**Project #21-045  
KW Distribution Center  
Located at approximately 950 N 850 W**

**REPORT SUMMARY...**

**RECOMMENDATION**

SHEET NUMBER  
**AD2.0E**  
OF:

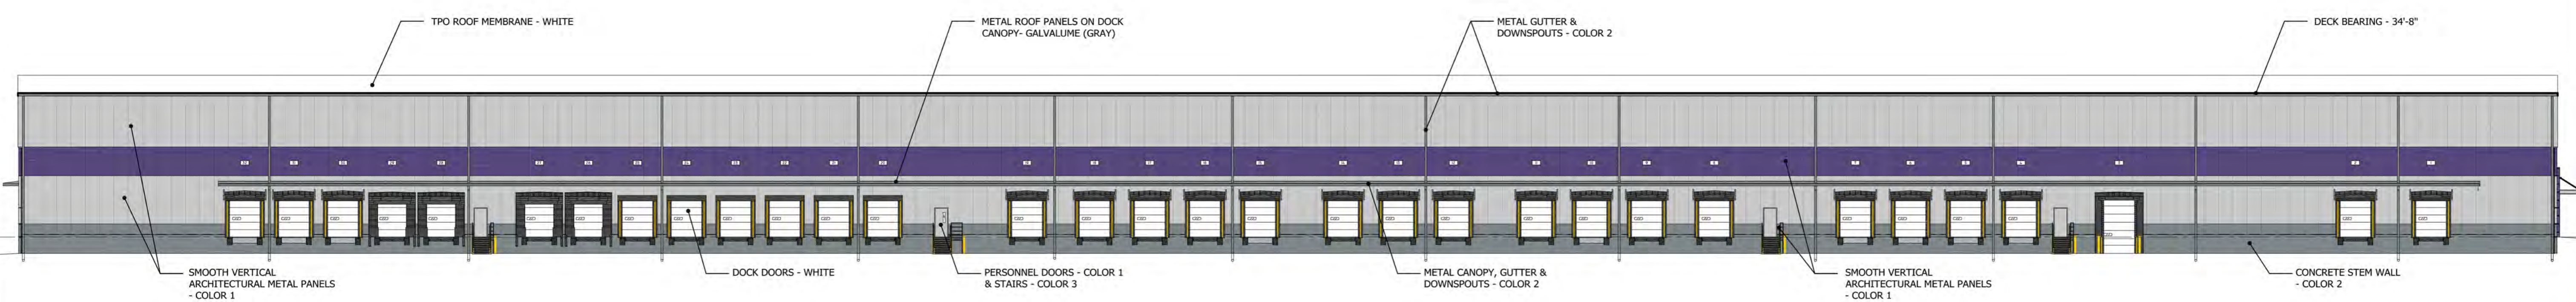
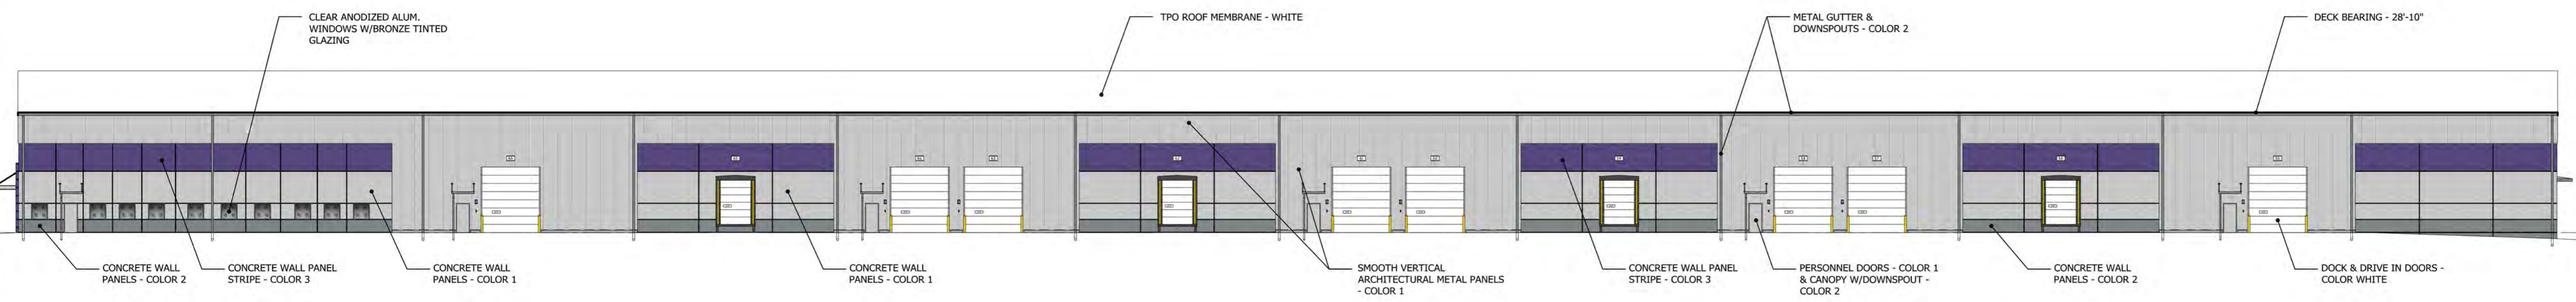
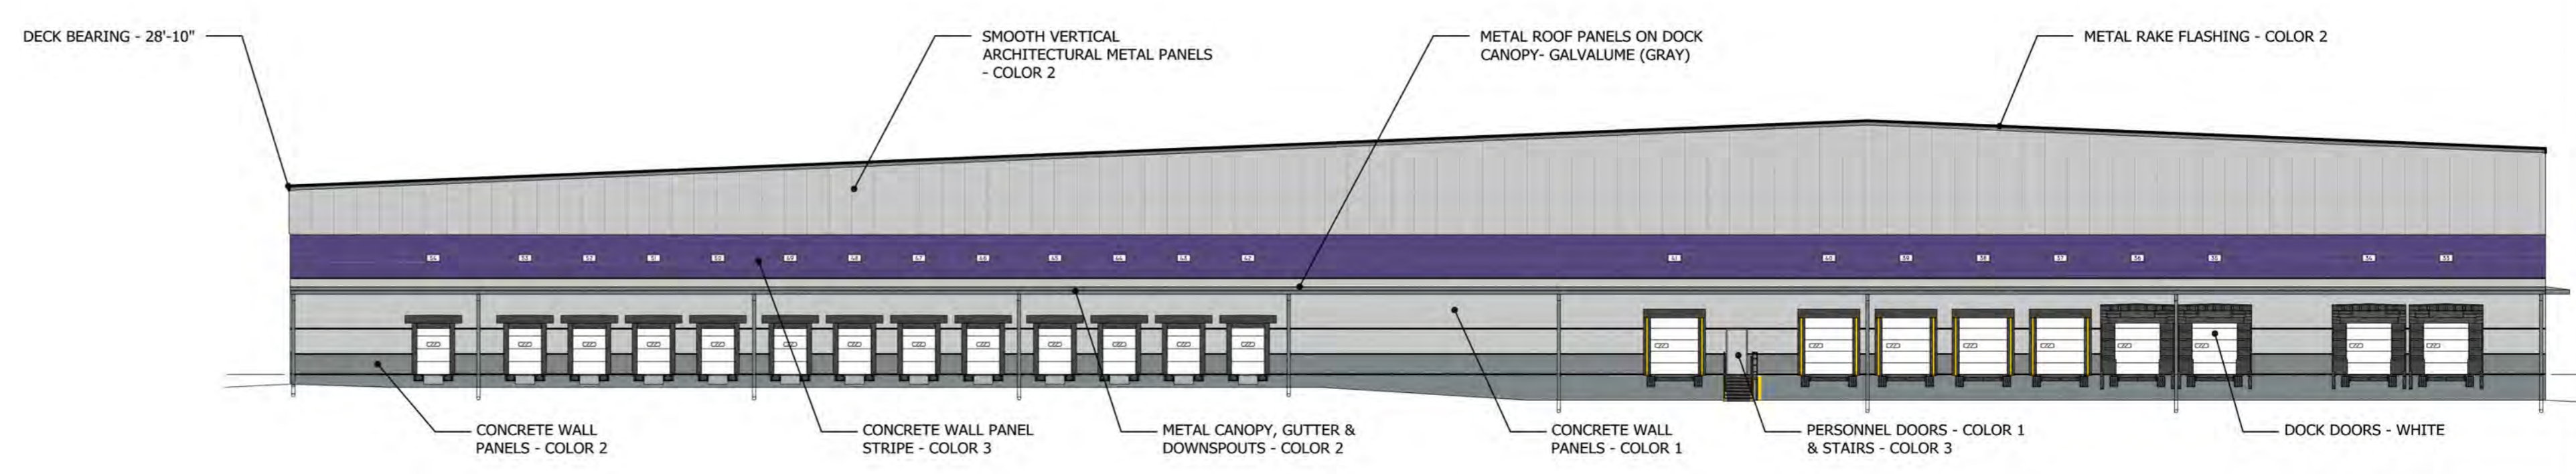
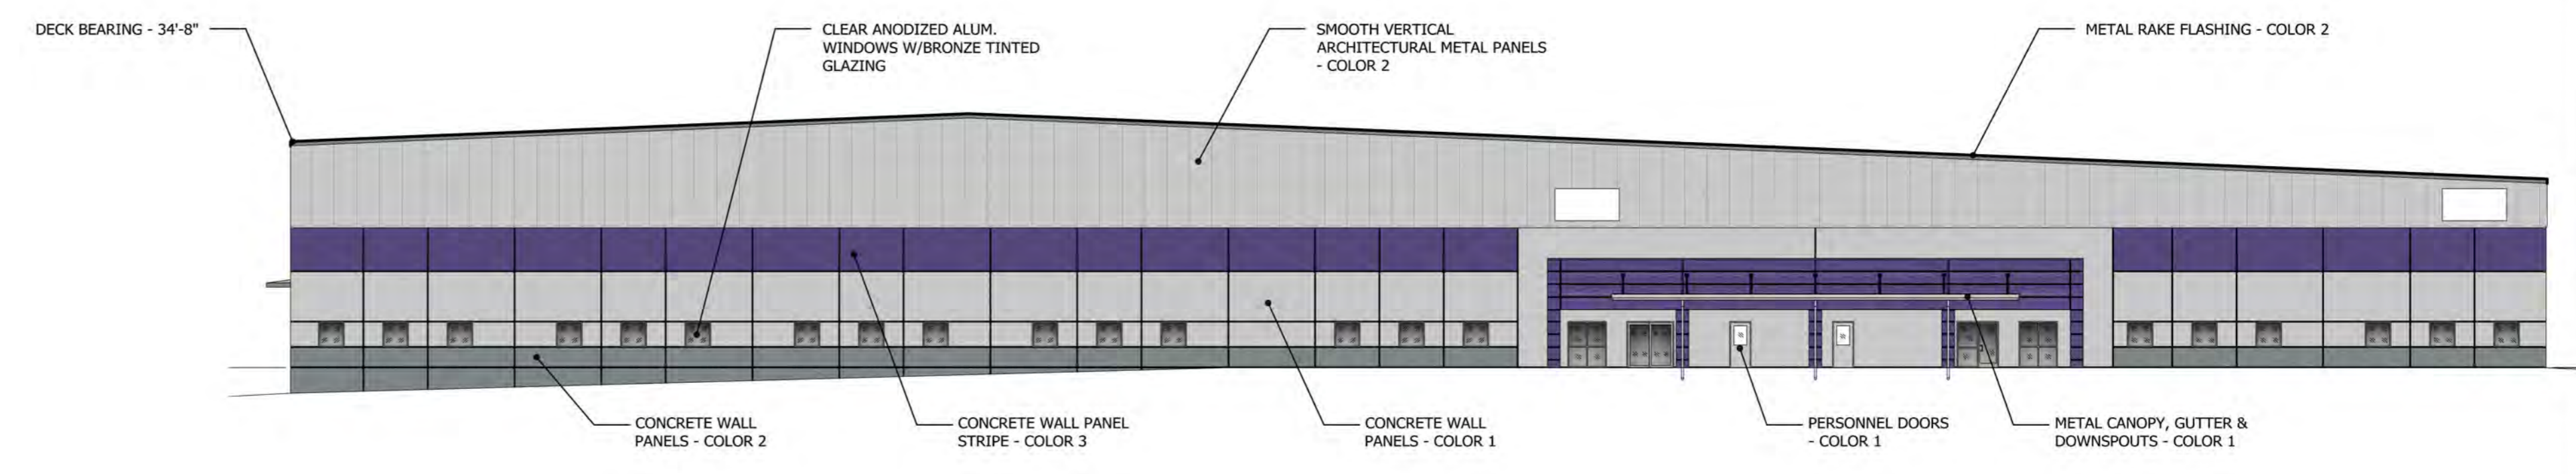
The LDC 17.12.060 requires new industrial buildings to be designed with high-quality materials and be aesthetically pleasing. Blank walls exceeding 40 linear feet are prohibited and ground floor street facing facades shall have a minimum of 30% transparency. Acceptable wall-breaks include windows, balconies, wall articulation or changes in color or materials. The building materials proposed are textured concrete wall panels, a series of windows along the east façade and entryway, vertical metal paneling, horizontal color variations and multiple loading docks on the north, south and east facades. The roof is proposed as a smooth white membrane material. Not considering the roof-gable area, the transparency along the east façade (front) is approximately 10% of the wall area (~600 SF of windows & ~6,000 SF of wall area). Throughout the other facades, the proposed design employs wall breaks every 40 feet or less with different colors, materials, canopies and doorway locations. As conditioned with additional transparency, the building design meets the requirements in the LDC.

1. All standard conditions of approval will be recorded with the Design Review and are available in the Community Development Department.
2. The transparency along the 800 West façade shall increase to 30% unless the Planning Commission utilizes their discretionary design authority and grants a reduction.
